SAFETY RECALL

Number SC0458

Mack Air Tank Volume GR

RECALL INFORMATION

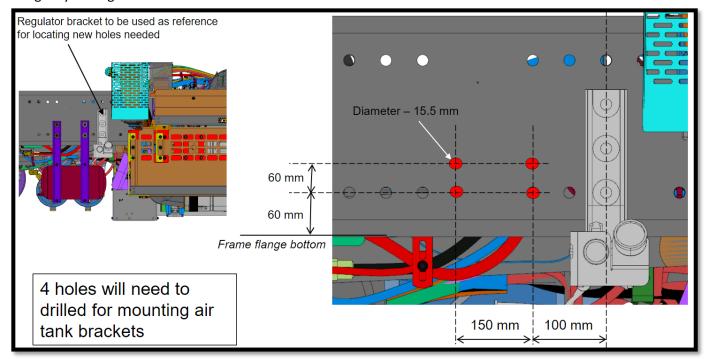
6. The retrofit air tank will be installed on the right-hand side of the truck on the frame.

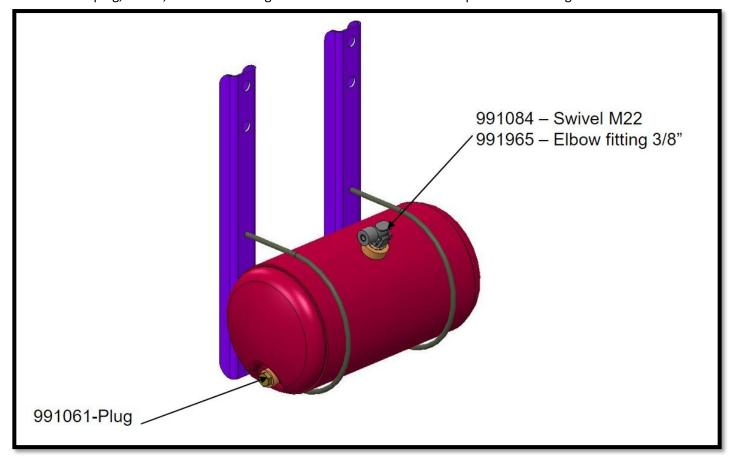
7. Begin by drilling four 15.5mm holes in the frame to mount the air tank brackets. Use the measurements below.

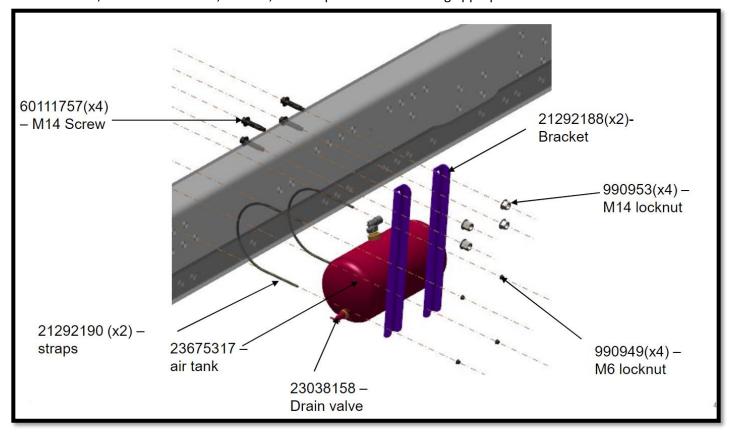
8. Ensure the plug, swivel, and elbow fitting have been installed on the tank prior to mounting it to the frame.

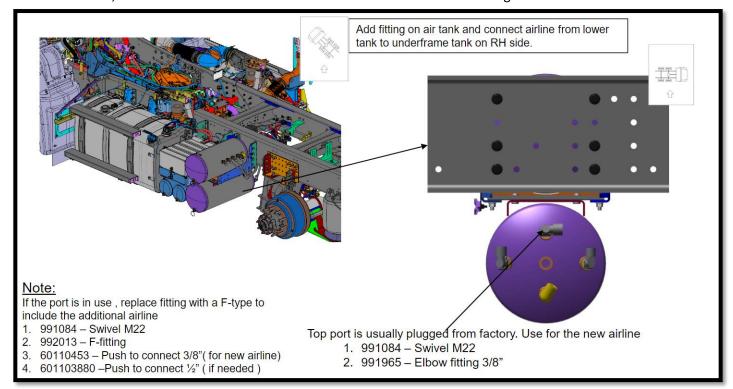
9. Once drilled, install the brackets, air tank, and straps to the frame using appropriate hardware.

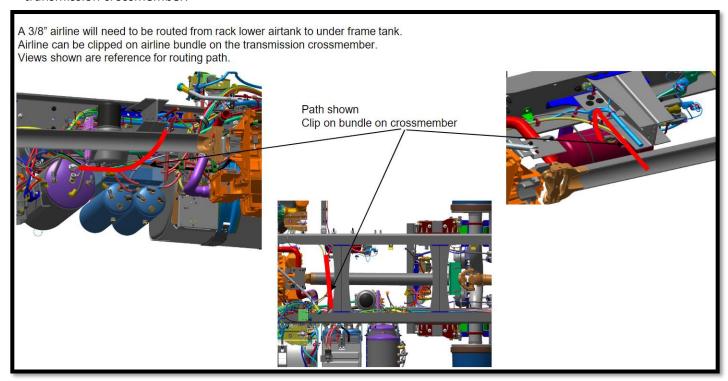
10. Once installed, connect the airline from the lower tank to underframe tank on right-hand side.
